ADDENDUM NO. 04 (MEPT)

Date of Issuance: April, 23, 2026

Project: **Replacement Elementary on Mustang Rd.**
Alvin Independent School District

Texas Arcadis Inc.
Project No.: 202502 - 30268973

P4.01
ENLARGED
PLUMBING PLANS

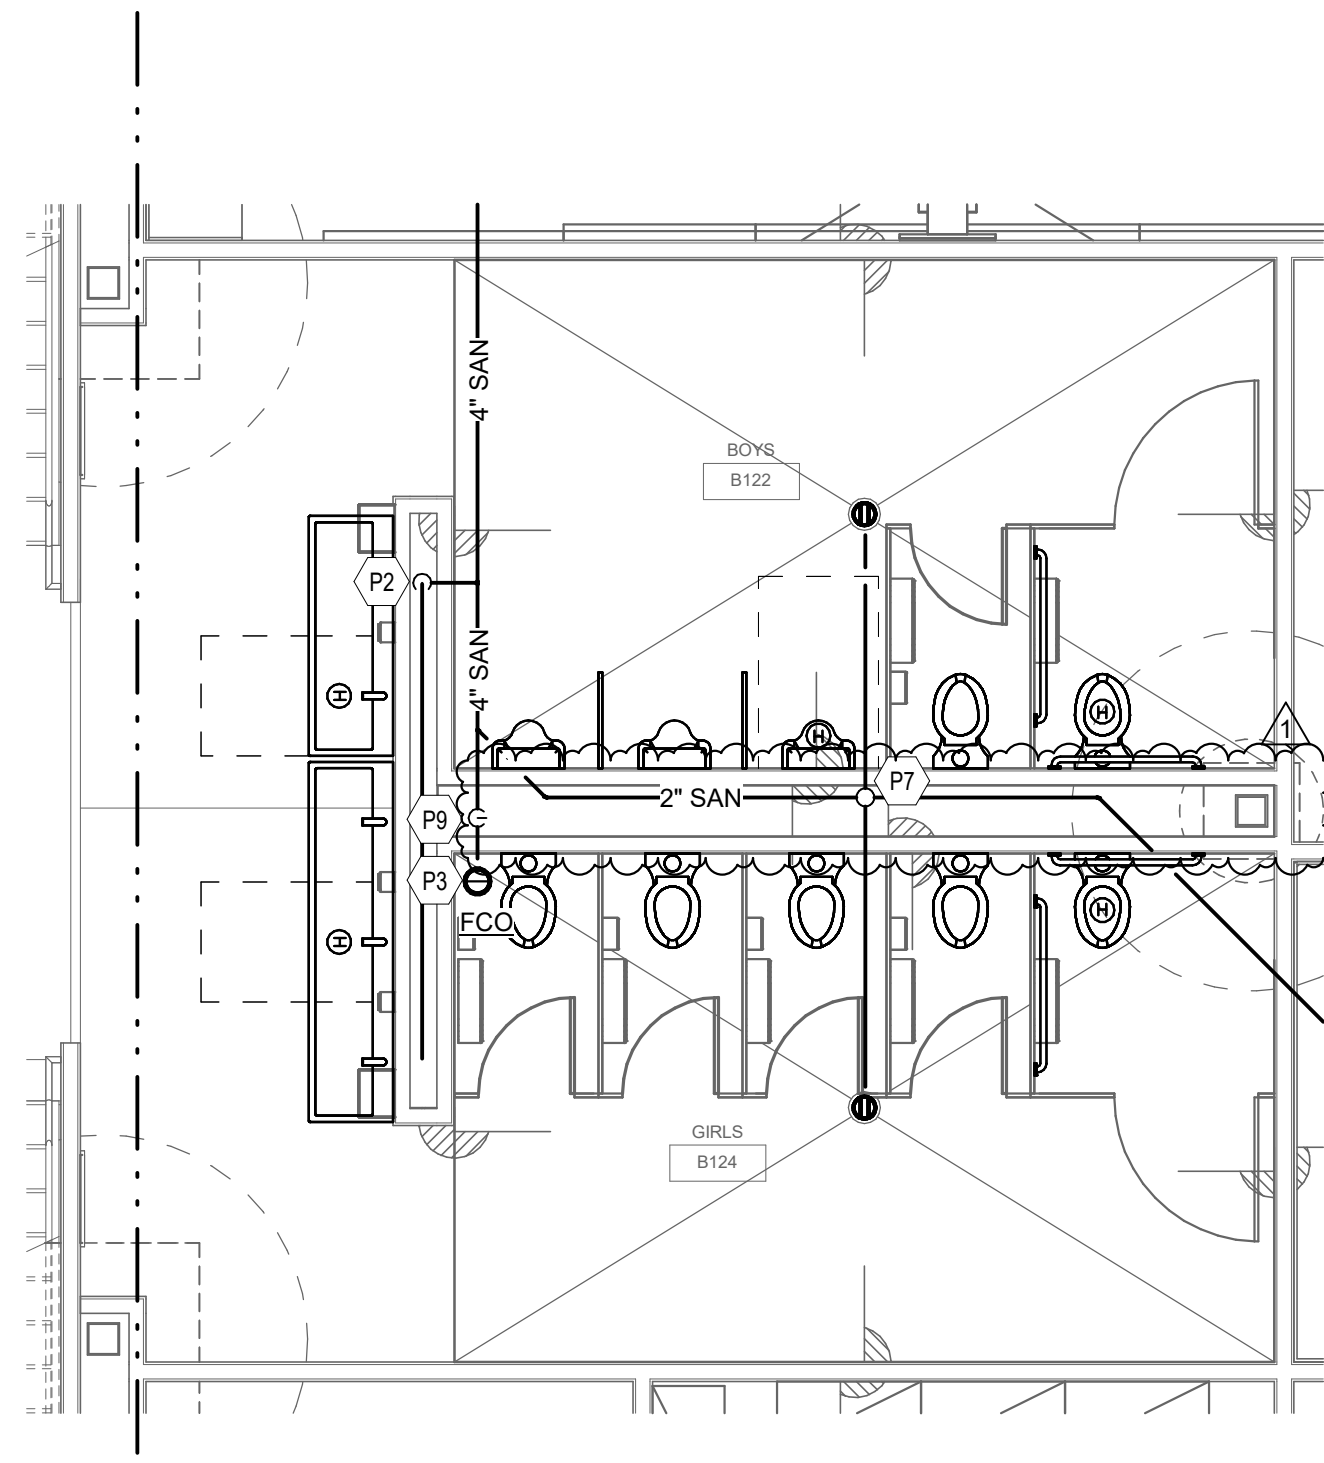
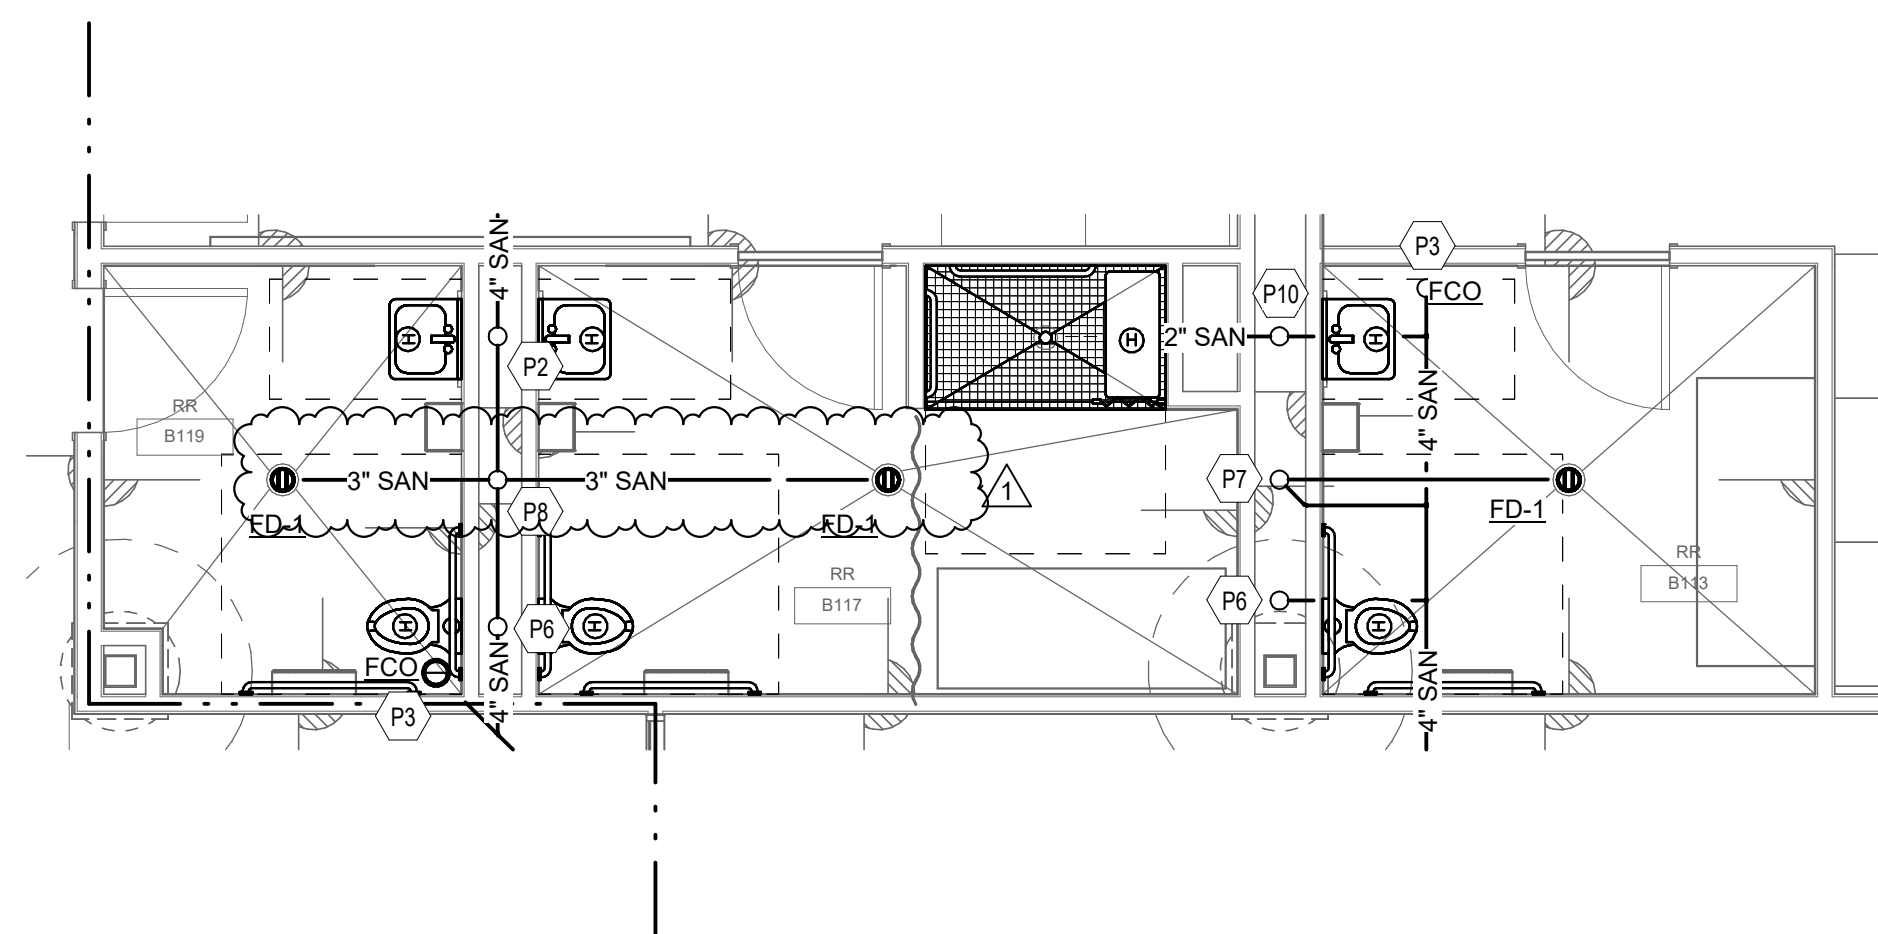
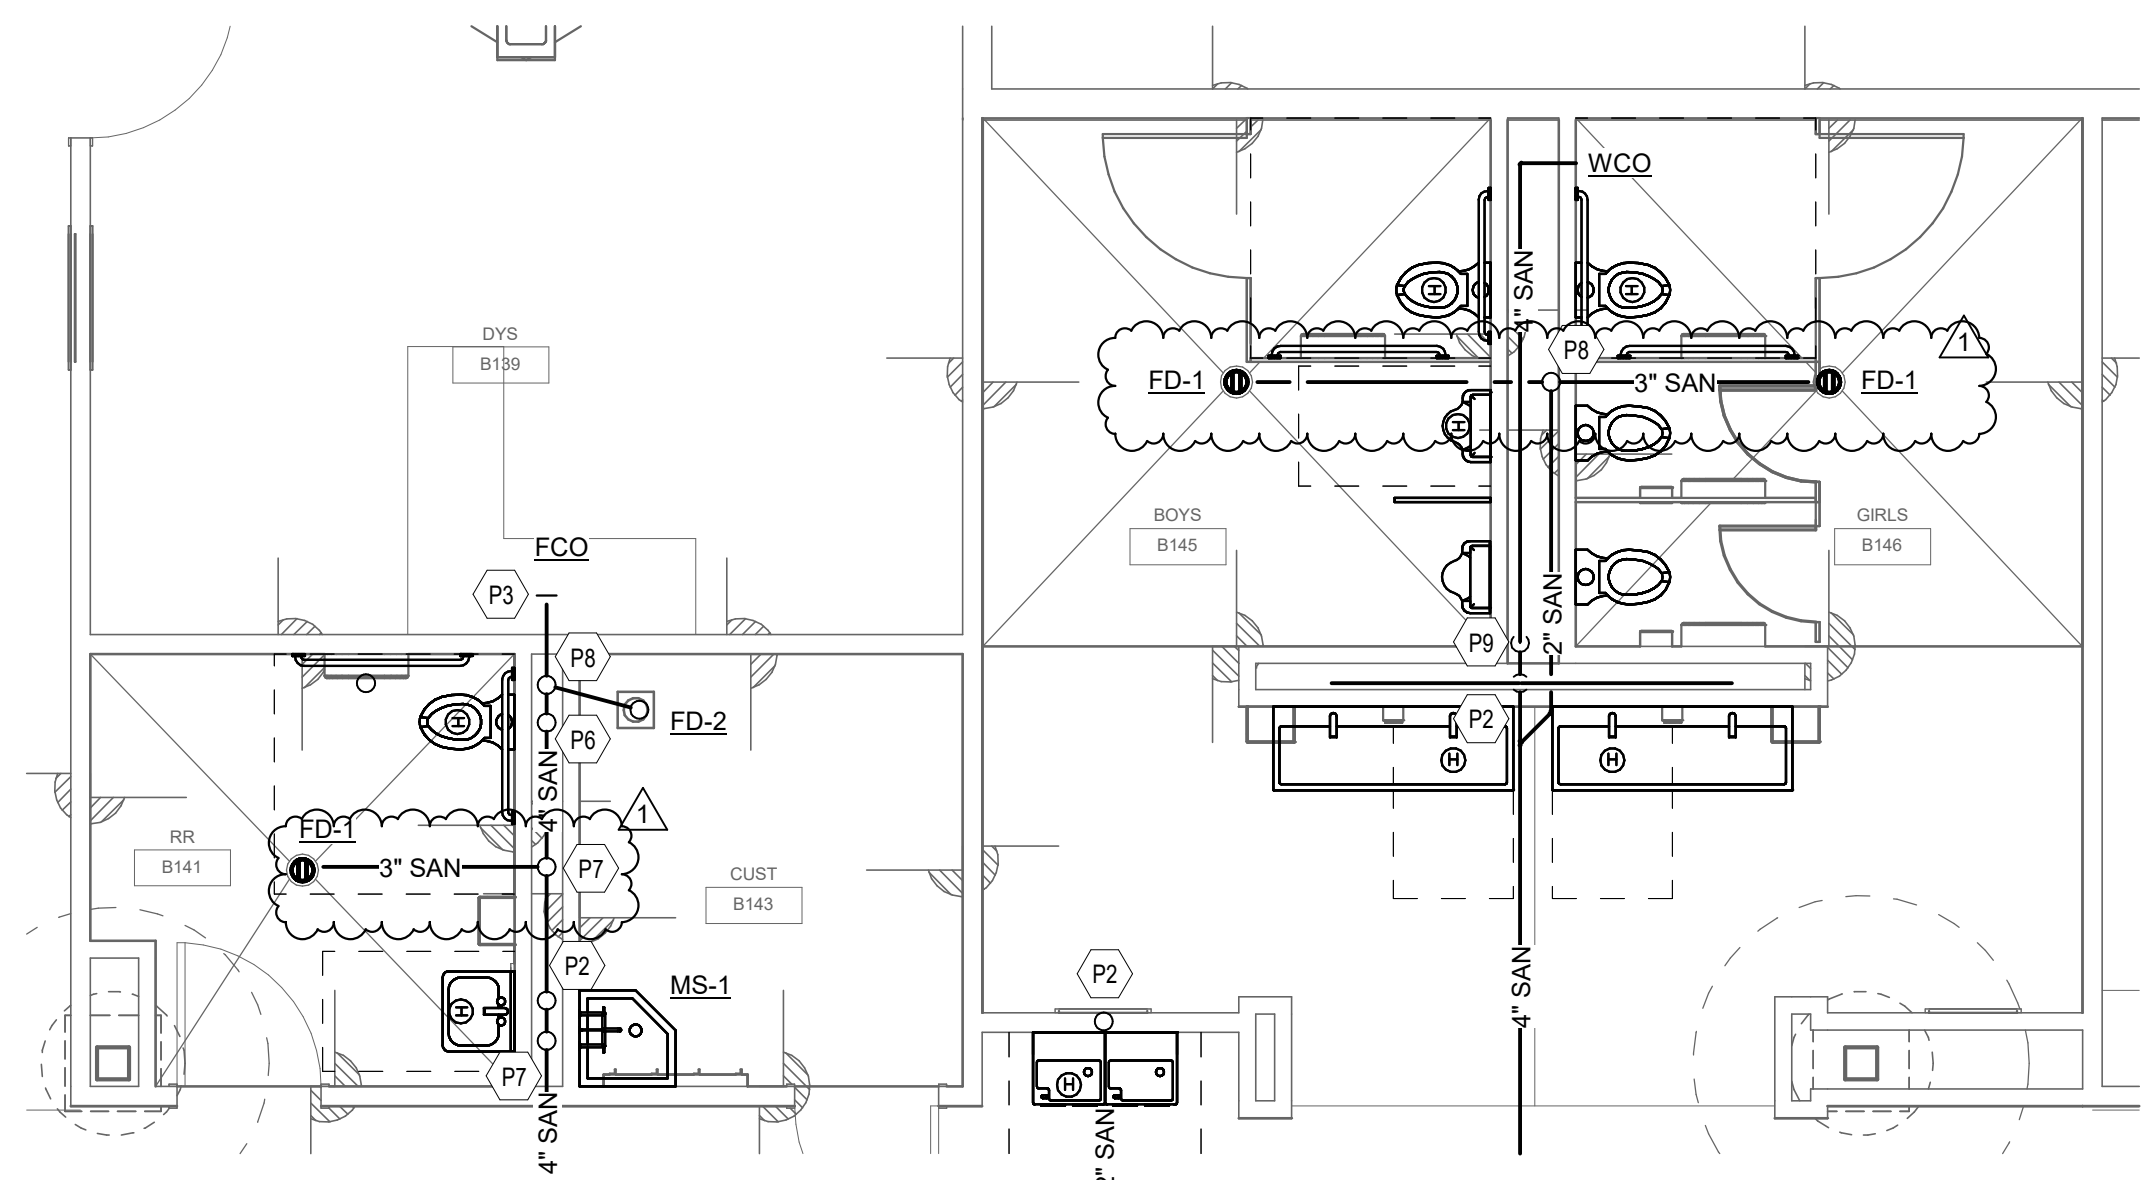
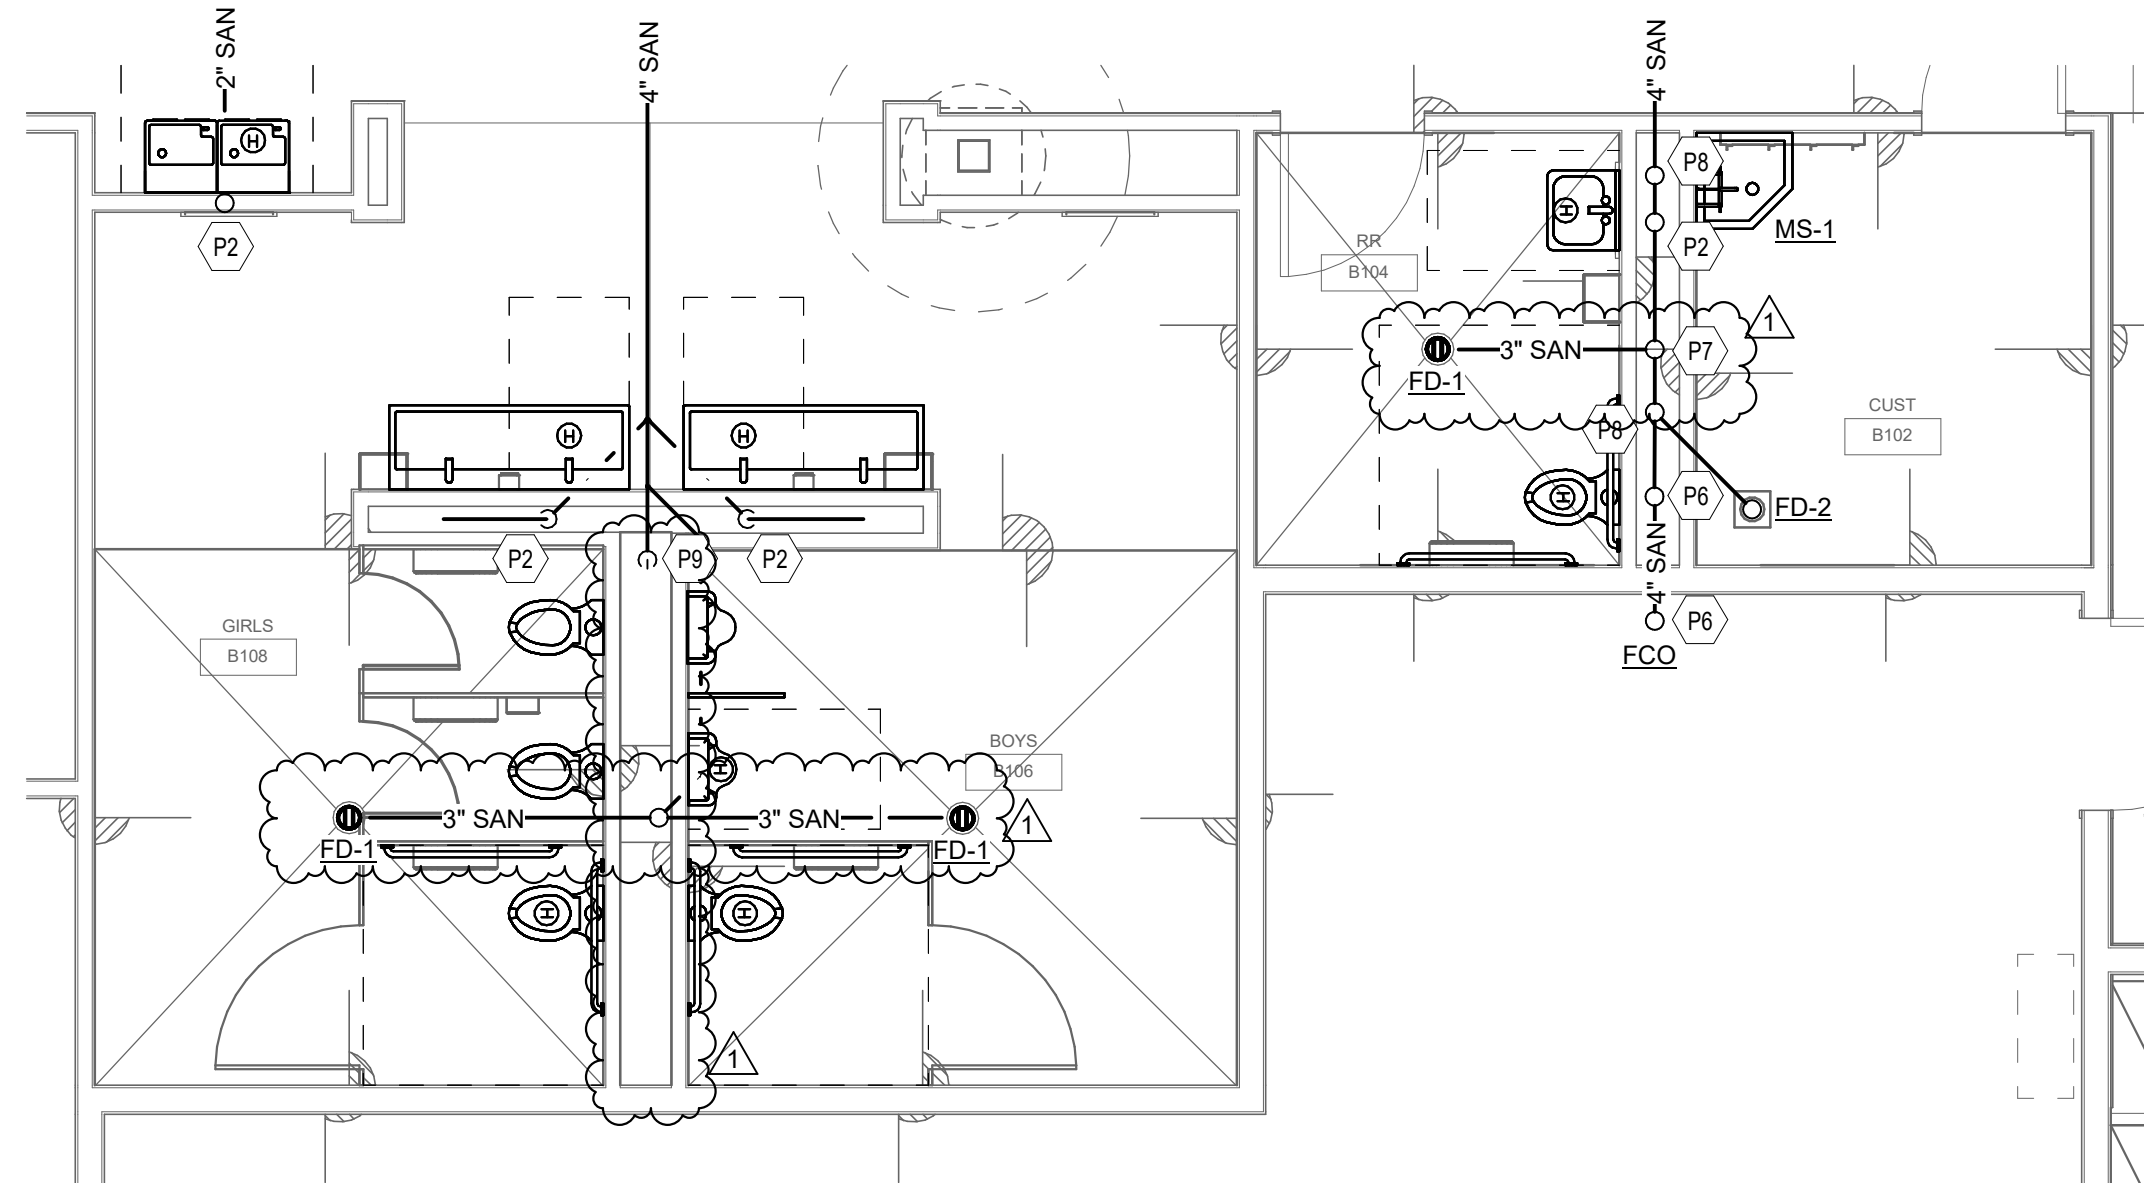
32. Sheet P2.23 – LEVEL 2 PLUMBING - AREA C2
 - e. Added routing notes.
33. Sheet P2.24 – LEVEL 2 PLUMBING - AREA D2
 - f. Added routing notes.
34. Sheet P4.01 – ENLARGED PLUMBING PLANS

- g. Revised tags and plumbing line routing.
35. Sheet P4.02 – ENLARGED PLUMBING PLANS
 - h. Revised tags and plumbing line routing.
36. Sheet P5.02 – LEVEL 1 - KITCHEN ENLARGED PLAN
